**Preliminary Change Request for the SNS
1.3 GeV-Compatible Ring**

BNL/SNS TECHNICAL NOTE

NO. 076

May 4, 2000

Figure 5: Layout of the proposed 1.3 GeV-compatible lattice for the Spallation Neutron Source ring.

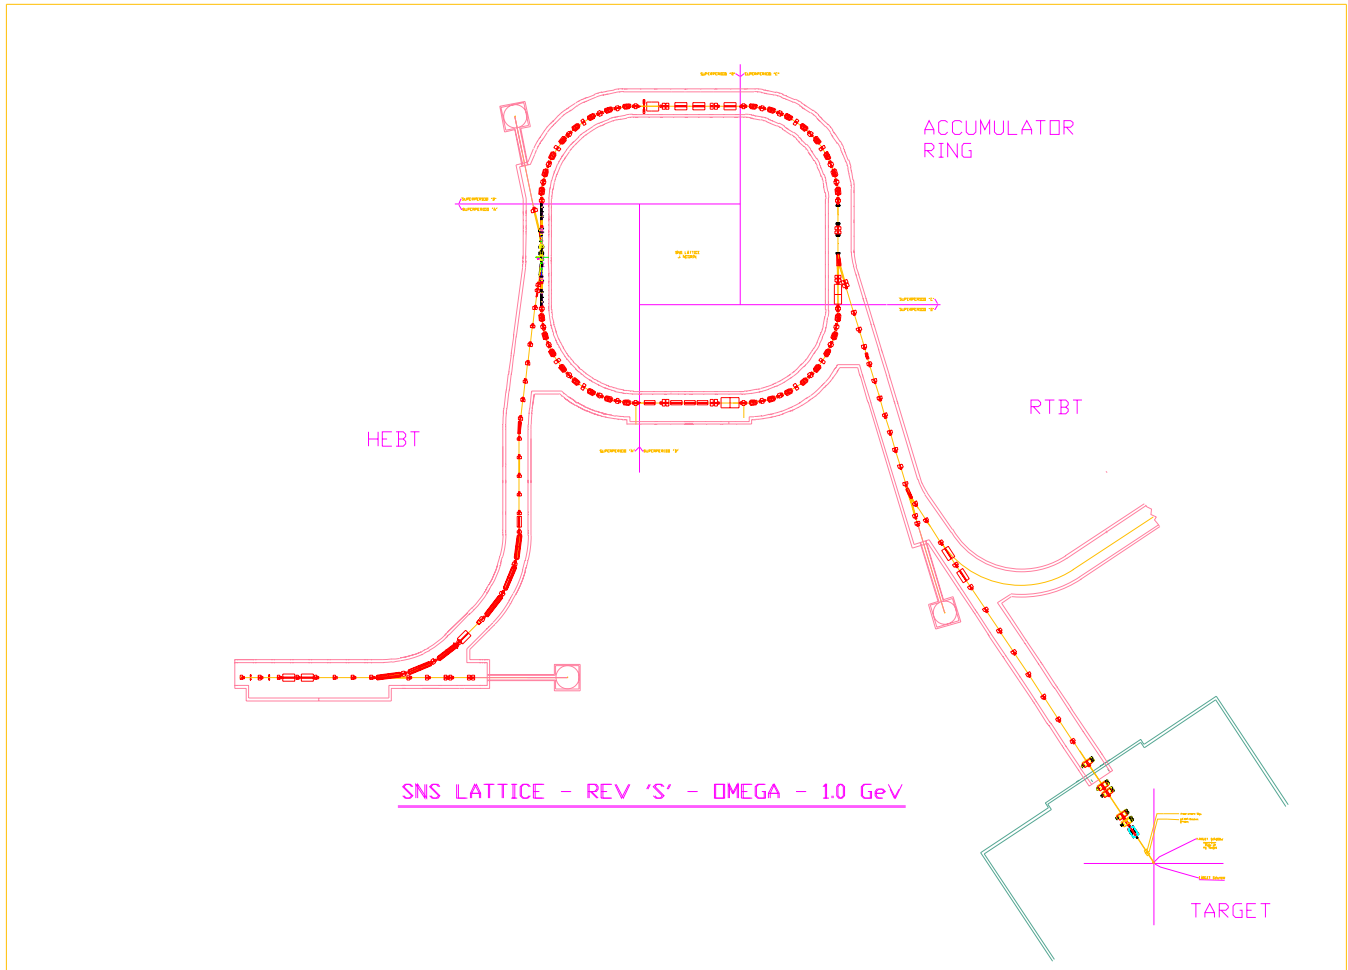
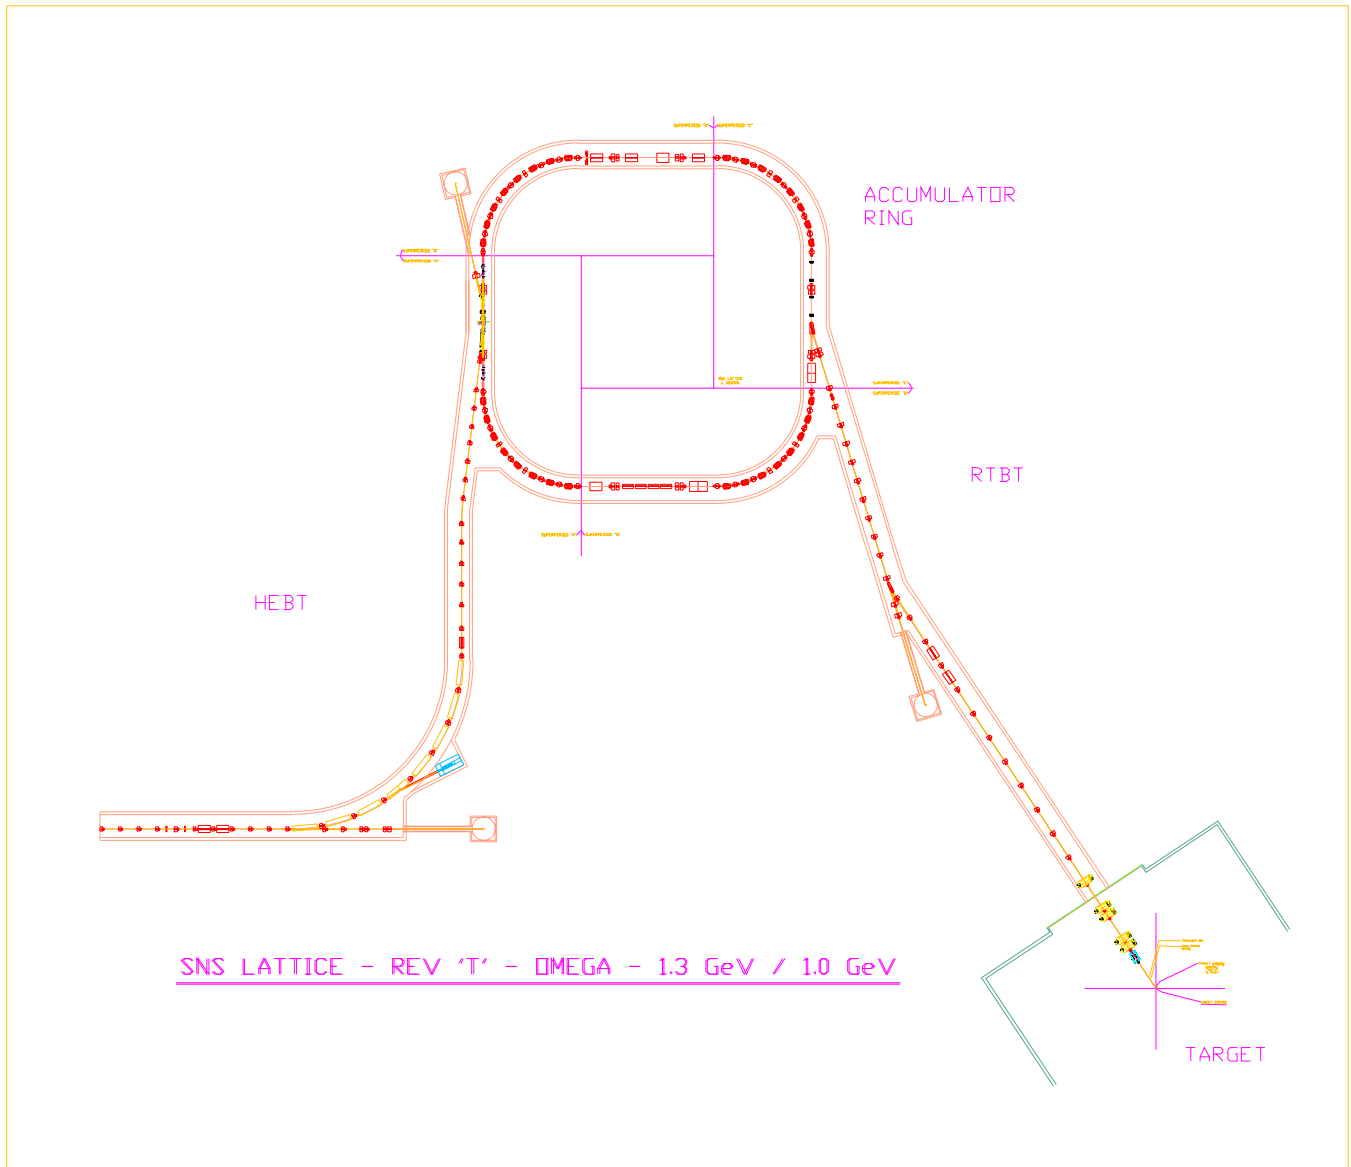
The proposed layout is again in omega configuration, as shown in Figure 5. The bending radius of the 90° achromat bend of the HEBT is increased due to the reduced dipole field. The HEBT length becomes 162 meters, 25 meters longer than the original. The length of the RTBT is assumed unchanged at 150 meters.

The general configuration of HEBT, ring, and RTBT remain the same. The length of HEBT line is increased by 25 m. The length of RTBT line is assumed to be the same, provided that the target can be relocated about 10 m from the original site towards the ring.

Figure 6: Schematic layout of the proposed 1.3 GeV-compatible SNS ring.

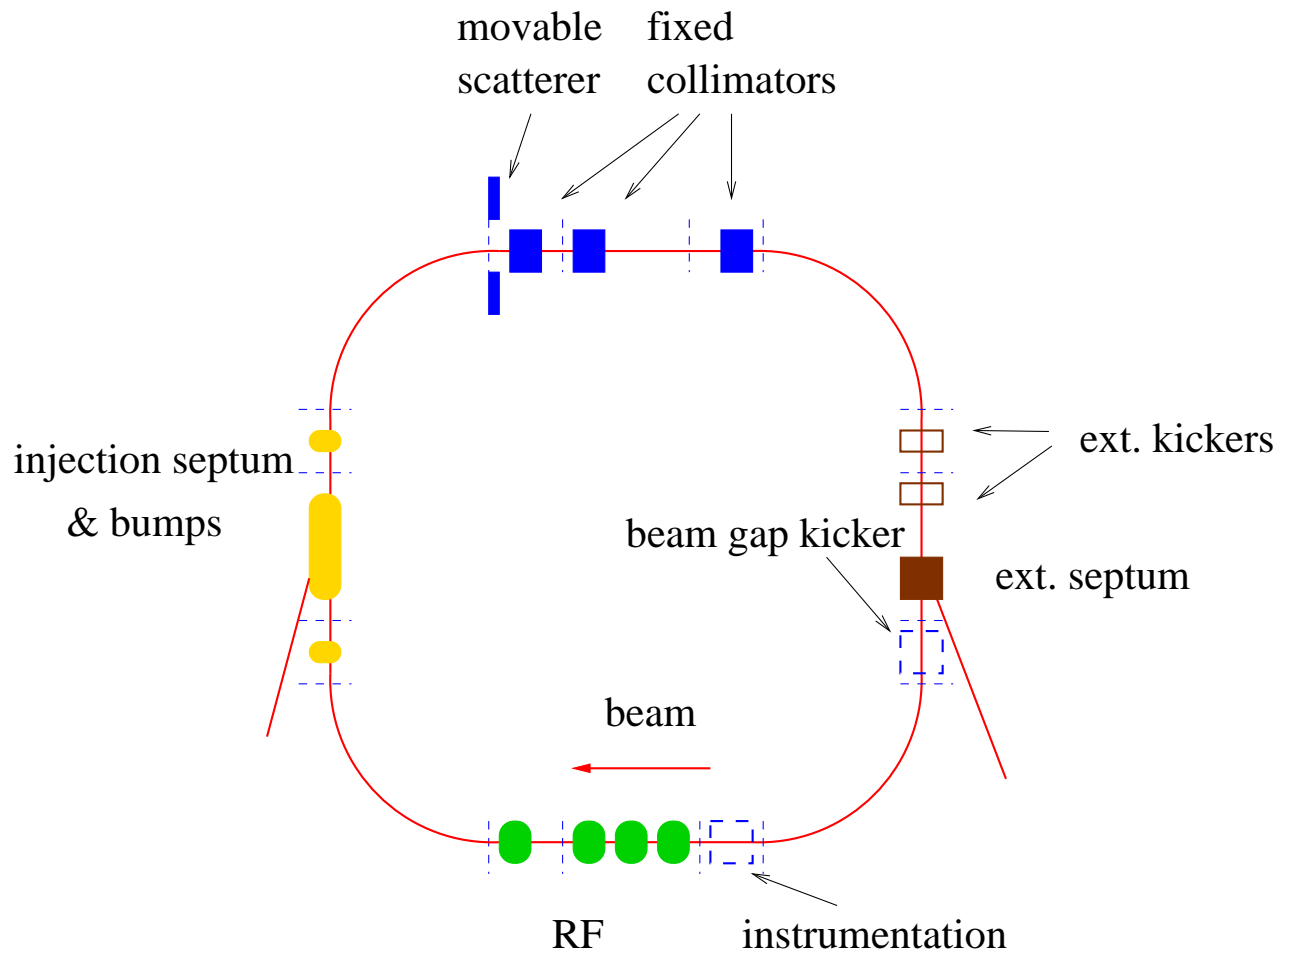
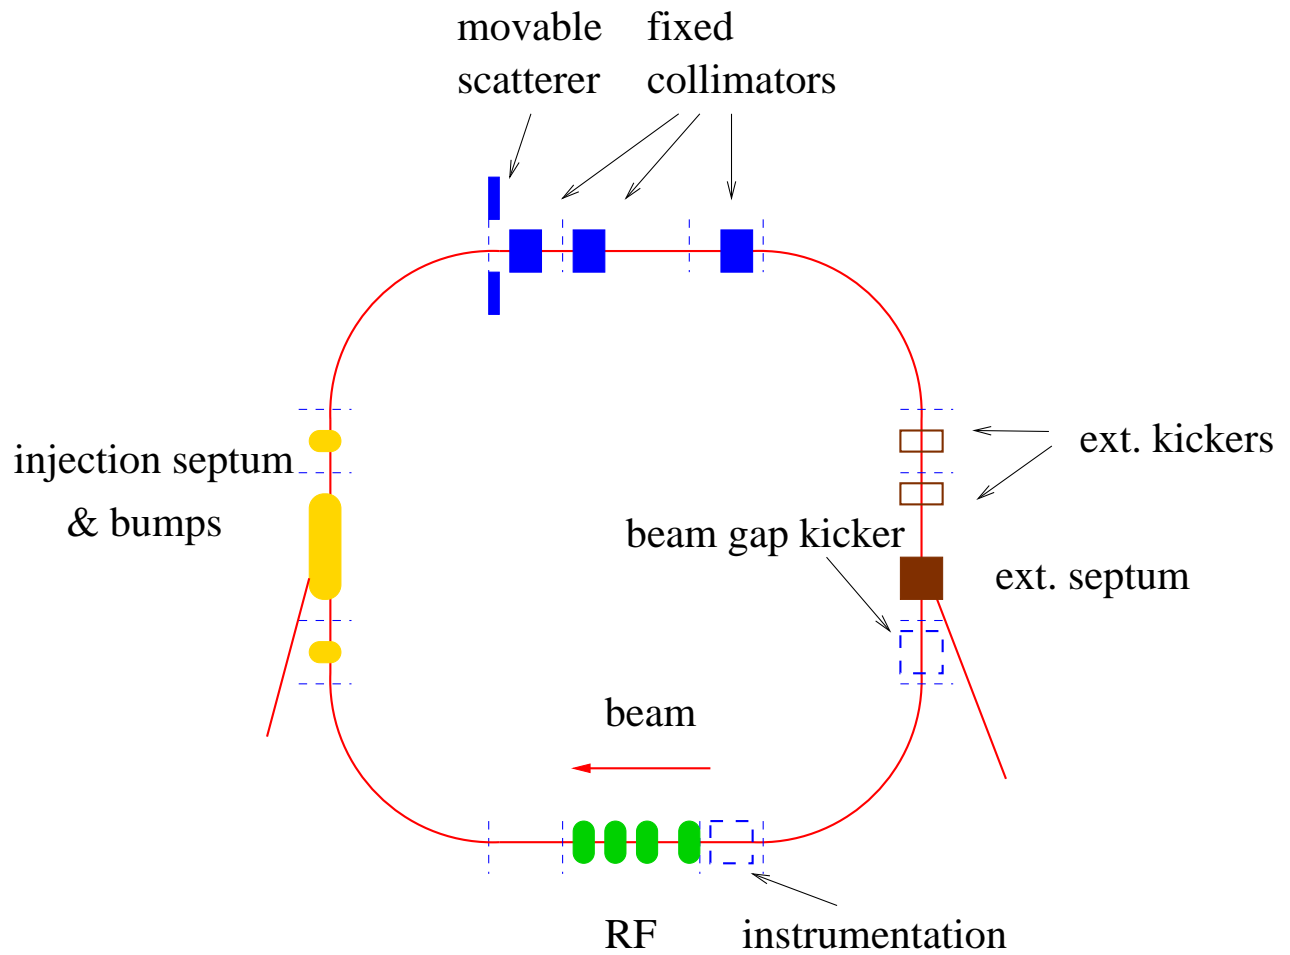
Figure 6 shows the schematic layout of the ring. The four straight sections are mainly designed for beam injection, beam collimation, extraction, and RF systems. All four RF cavities (three $h = 1$, one $h = 2$) are located in the same drift space. Figure 7 shows the layout of the lattice magnets (dipole, quadrupole, sextupole, and correctors) in one of the four lattice super-periods. Dipole correctors in both the arc and straight sections are used for misalignment closed orbit correction. The sextupoles in the arc sections are used for chromaticity adjustment, off-momentum optics matching, and momentum aperture improvement. The multi-layer correctors in the straight sections are used for resonance corrections.

Each of the 4 lattice period contains a straight section that has one 12.50 m and two 6.85 m drift spaces. The total straight section length is about 104.8 meters. For each drift space, the “overhead” taken by correctors, BPMs, vacuum pumps, bellows, flanges, etc. is about 1.6 meters. The total usable length is about 85 meters. Each period has 5.2 m – 11 m – 5.2 m structure. The total unclaimed drift space is adequate for an upgrade to a 1.3 GeV machine.

The ring circumference is increased by 27.12 m, all resulted from the increase in straight length. With matching, the lattice function in the arc remain the same. The maximum β function in the straights is increased from 19.7 m to 26.7 m. The ring dispersion remains the same. The ratio between maximum and minimum β is increased from about 7.5 to 10.7 across the entire ring. The lengths of straight section are increased from 9.04 and 5.45 to 12.5 and 6.85 m, respectively. The working points remain the same.

Figure 9: Lattice functions at tunes (Q_x, Q_y) of $(6.30, 5.80)$ for one super-period of the proposed 1.3 GeV-compatible SNS ring.

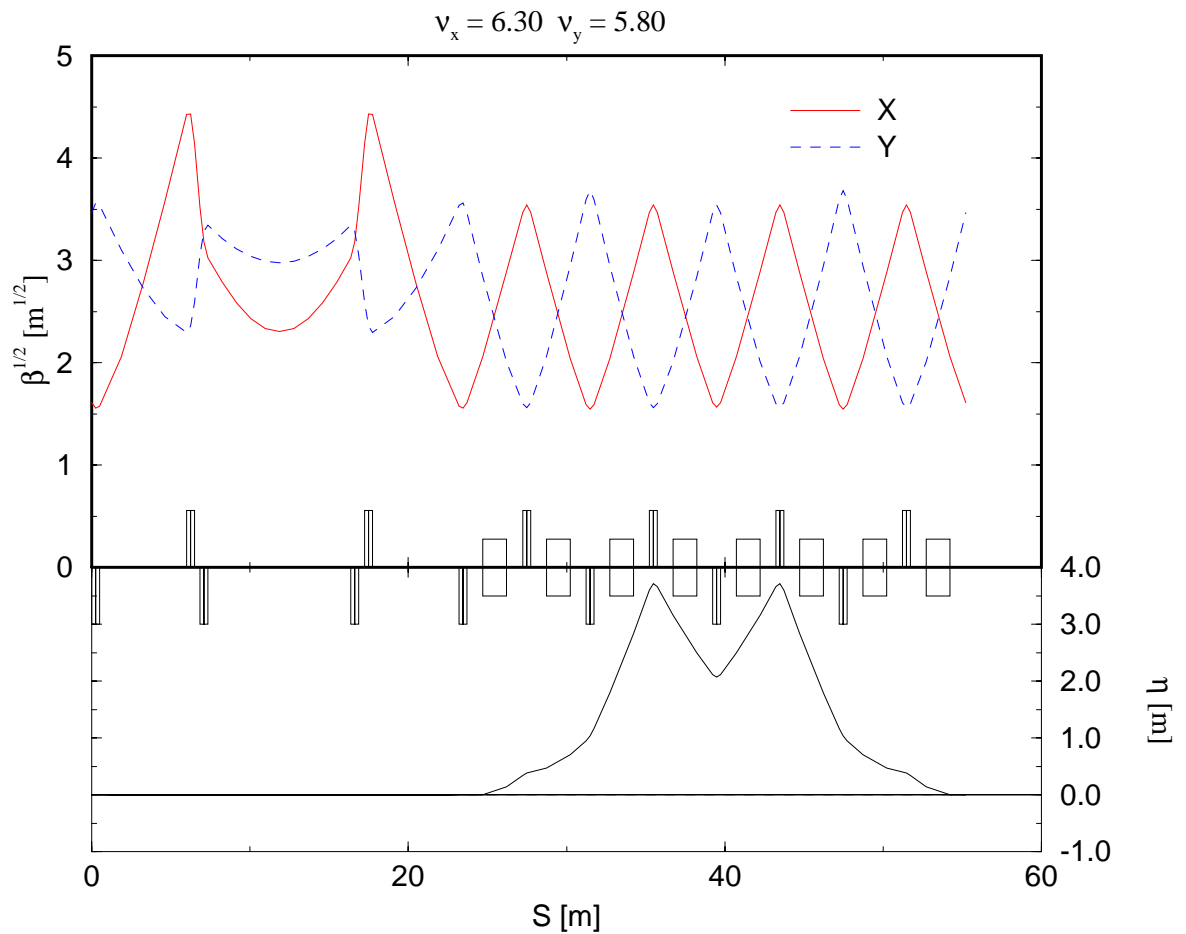
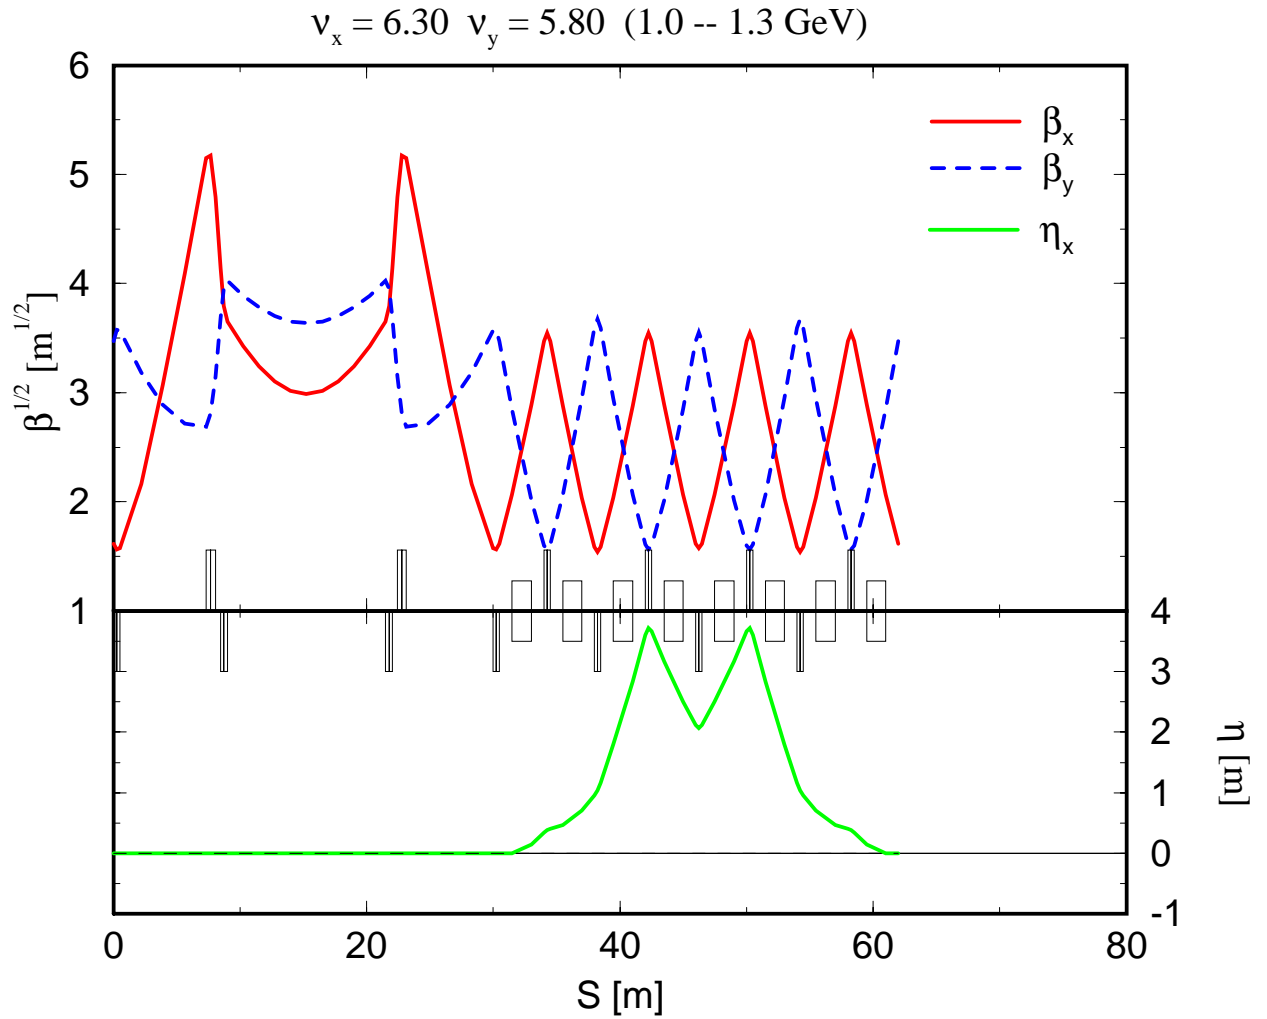
The working points remain the same as the original hybrid lattice. At the nominal working point, the arc and the straight section lattice β function is matched, ensuring lowest possible β function in the arc for given cell length. The horizontal betatron phase advance is 360 degrees across each arc section so that the dispersion function is zero in all the straight sections. Comparing with that of the original hybrid lattice, the β_{max} to β_{min} ratio of the proposed lattice is increased from about 7.5 to 10.7.

Figure 17: Horizontal schematic layout of the beam injection region of the proposed ring operating at 1.3 GeV.

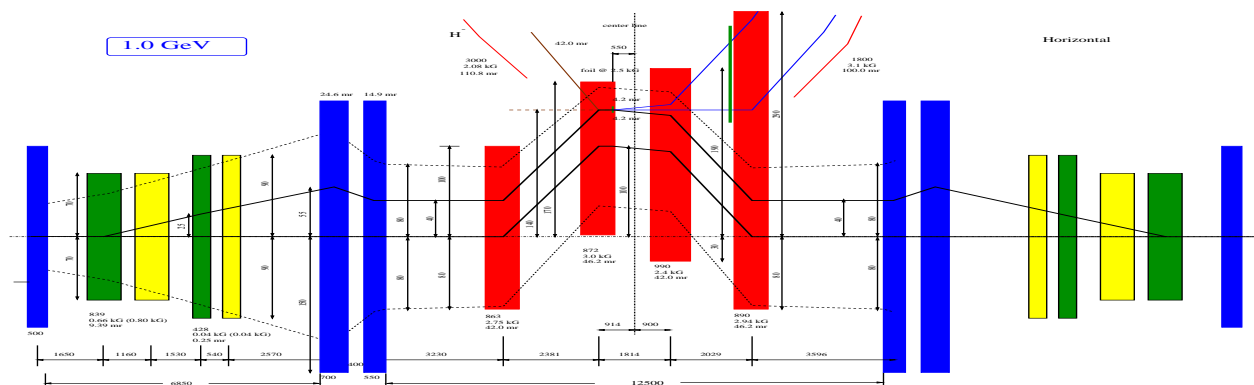
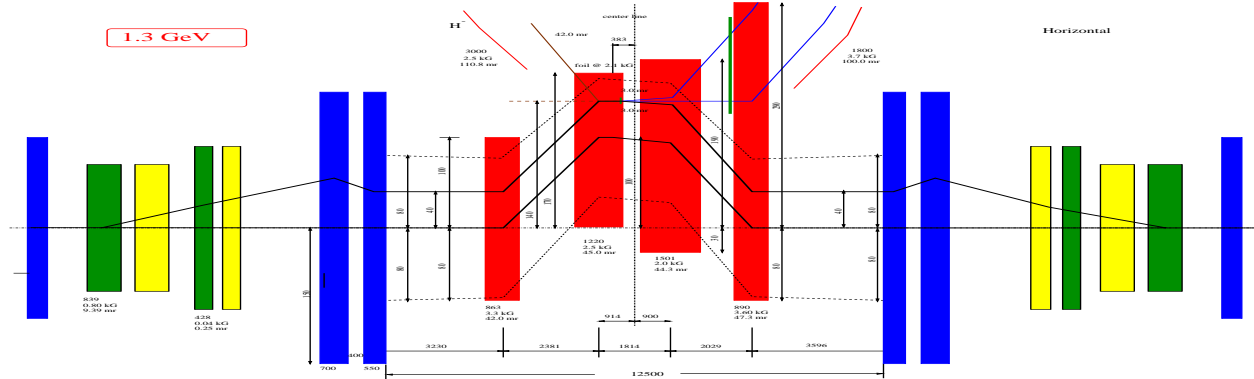
Extra space is reserved for the replacement of the two dipoles located near the center of the injection. When the machine is upgraded for 1.3 GeV operation, these two dipoles will be replaced by longer magnets operating at lower fields.

Comparing with 1 GeV operation, for 1.3 GeV operation two injection dipoles need to be

replaced by approximately 40% longer units operating at reduced (20%) fields, as shown in Figure 17. The location of the foil mechanism is also changed. Major parameters for the injection magnets are listed in Table 22. The 2.5 kG field of the magnets INJSEPTM1 and

Figure 16: Extraction layout and closed orbit of the 1.3 GeV-compatible ring. The two kickers marked with blue color are reserved for 1.3 GeV operation.

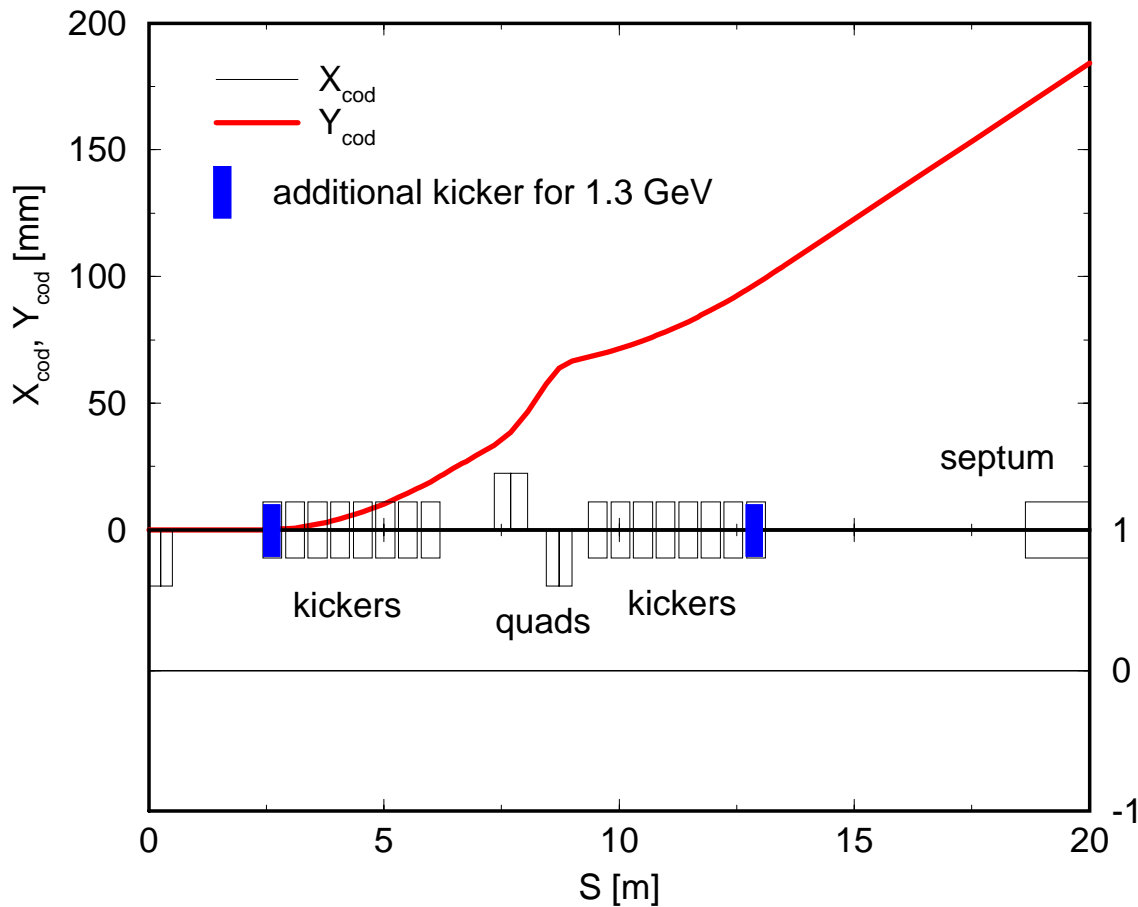
Space is reserved for the addition of two extra kickers for 1.3 GeV operation without changing the location of the existing 14 kickers.

The number and strength of extraction kicker modules remains the same, but the dimension is increased. The length of extraction Lambertson septum is increased from 2.1 to 2.4 m. Space is reserved for addition of two kicker modules for 1.3 GeV operation.
